IN THE DRAWINGS:

REMARKS

Fig. 3

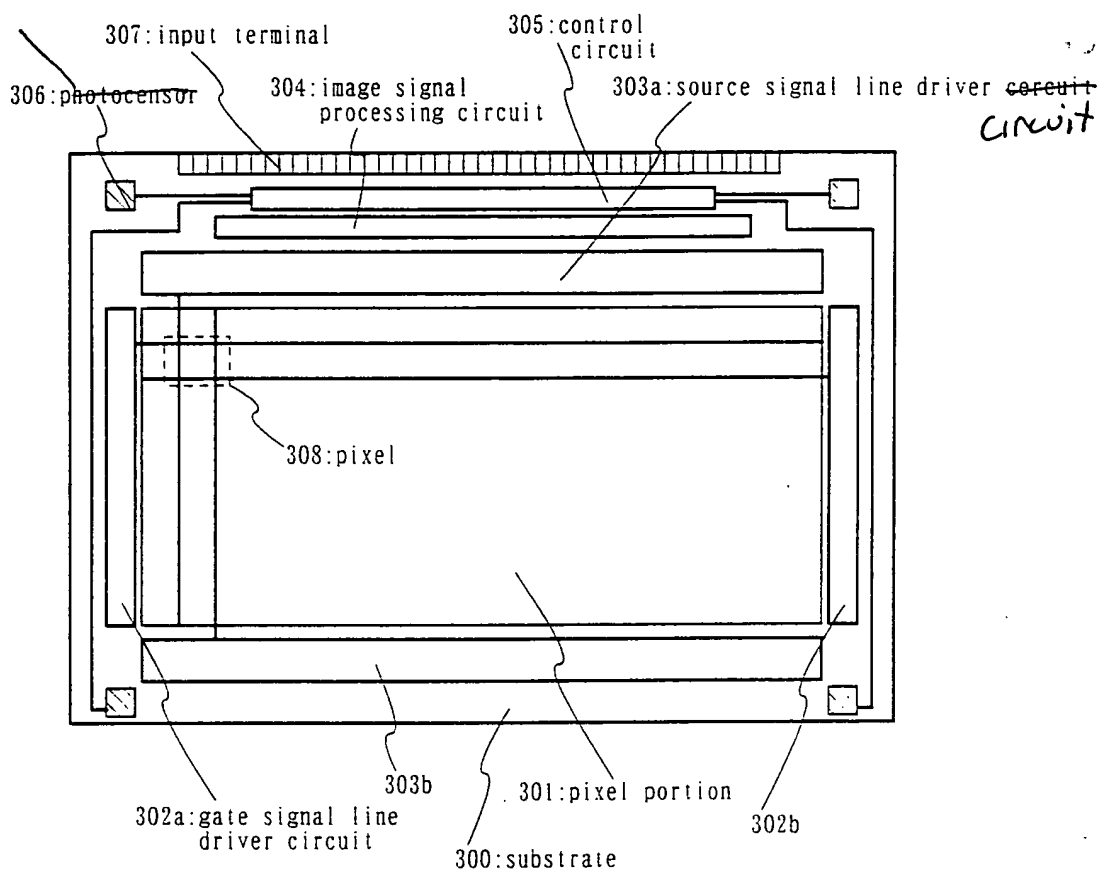
The attached sheets of drawings include changes to Figs. 3, 5B, and 15 to correct informalities therein. These sheets replace the original sheets containing these drawings. Applicants are also submitting formal drawings herewith.

Upon preparation of the formal drawings, Applicants noted that there were several misspelled words in Figs. 3 and 15 and an incorrect lead line in Fig. 5B. Applicants are amending each of these drawings to correct these informalities. No new matter is being added. Therefore, it is respectfully requested that this amendment be entered and allowed.
